Re: Significant Corrective Action Permit Application
230 Ridgefield Road, Wilton, CT

Following comments received at the Wetland Commission's June 10, 2021 meeting, the following responses are provided.

REVISIONS:		DRAWING TITLE:
1	6-22-21	NOTES EXPANDED FOR STABILIZATION
PROJECT:		SMITH FAMILY 230 RIDGEFIELD ROAD WILTON, CONNECTICUT
DATE:		APRIL 26, 2021
SCALE:		AS NOTED
DRAWING NO.:		WP-5

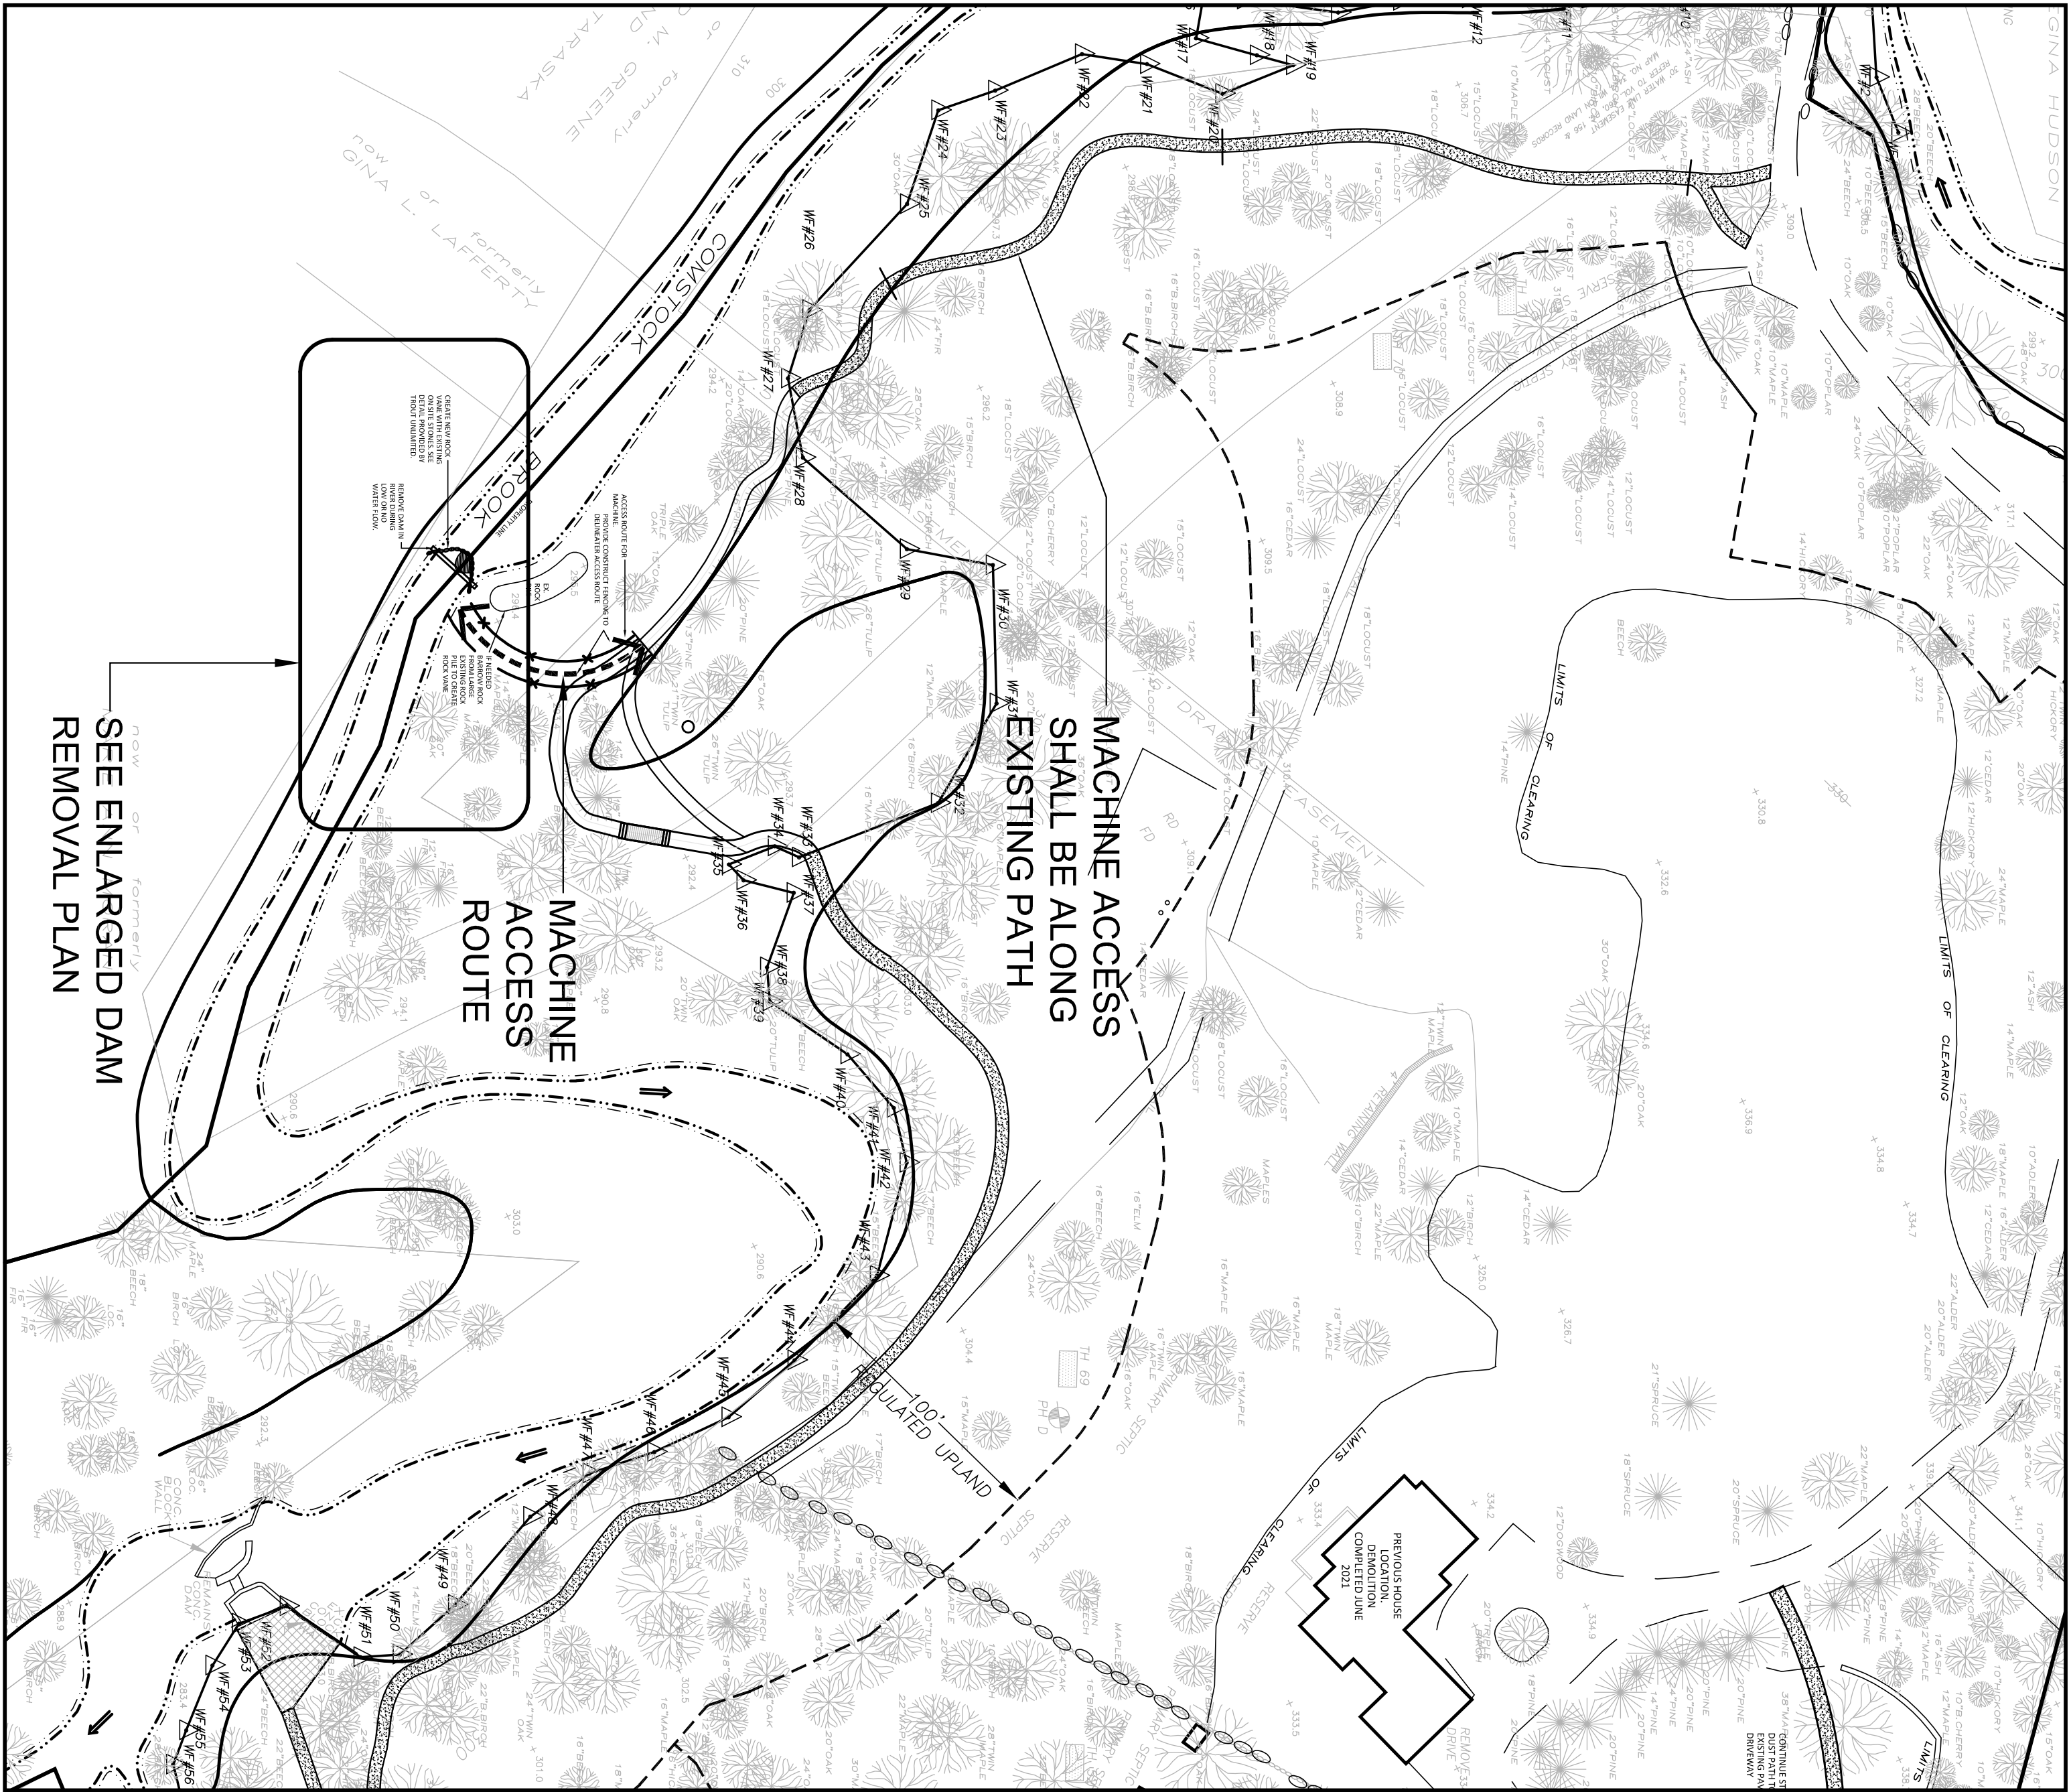
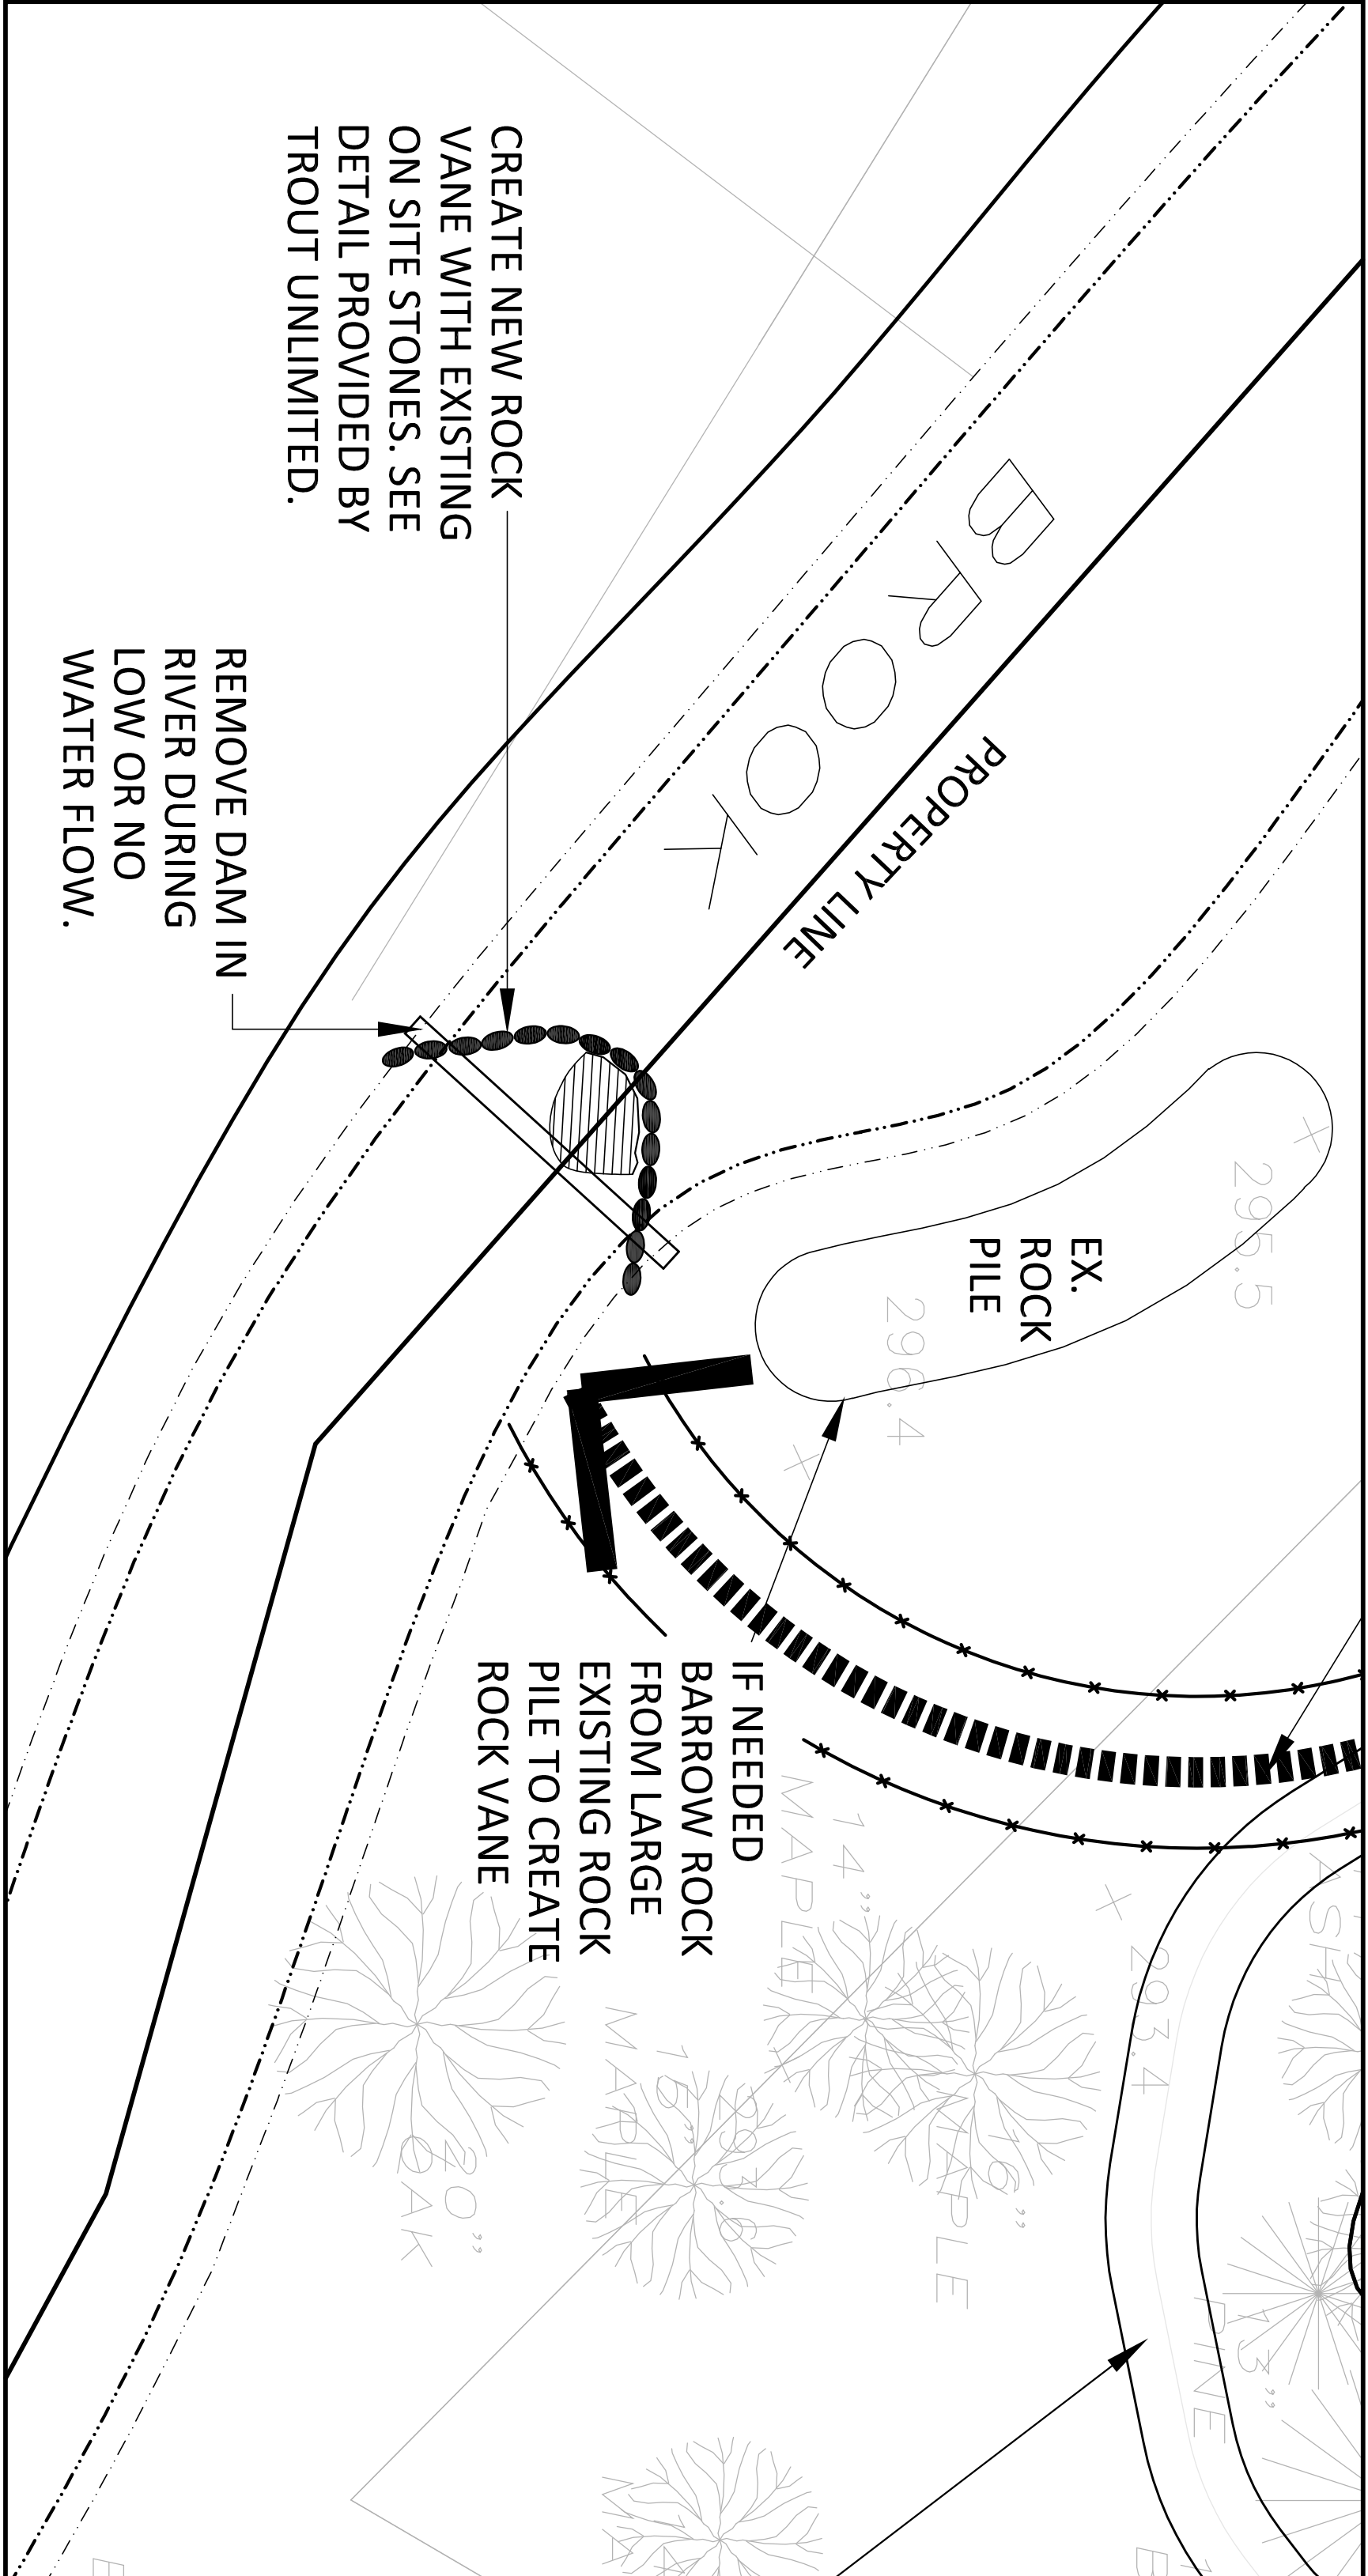
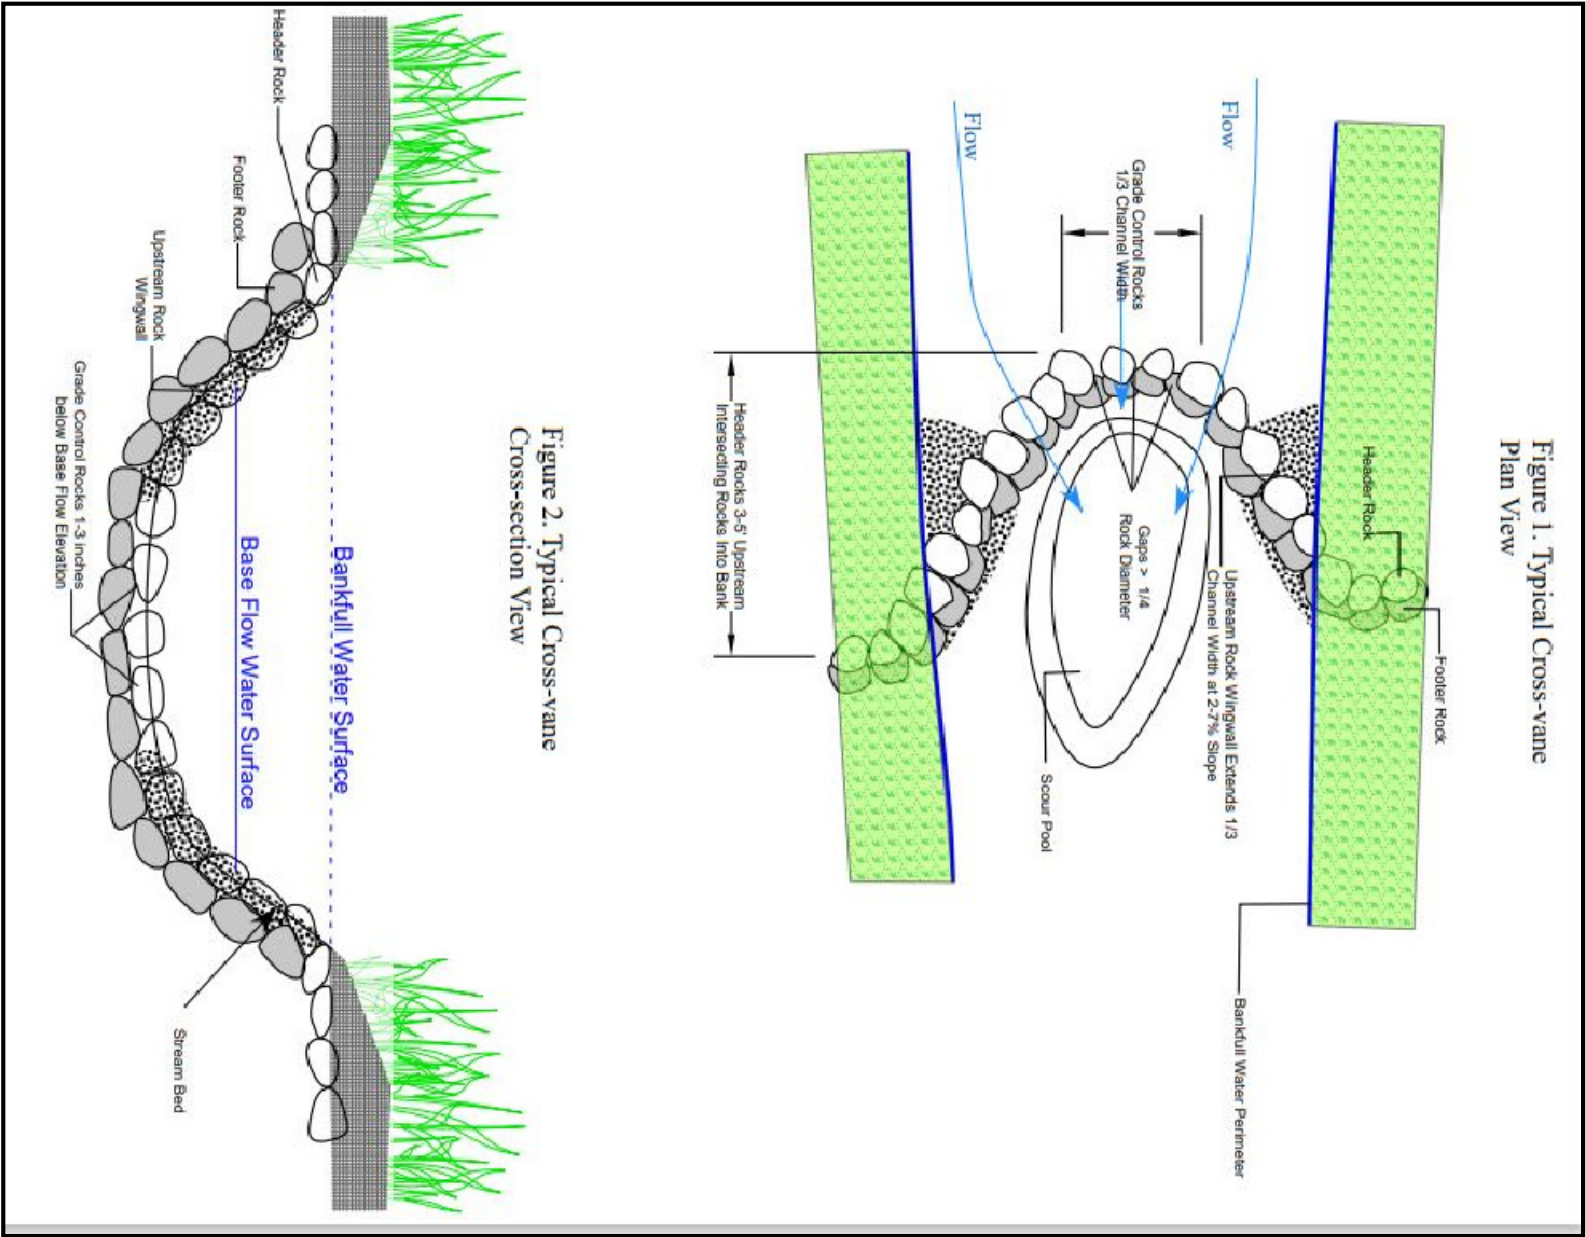
7. The staff requested that additional details and notes be added relating to the dam removal. Erosion and control notes have been expanded to clarify the area must be left with all areas stabilized, no soil will remain exposed, and that if any trees or shrubs are damaged during the removal that they are replaced on a one to one basis. Please refer to sheet WP-5.
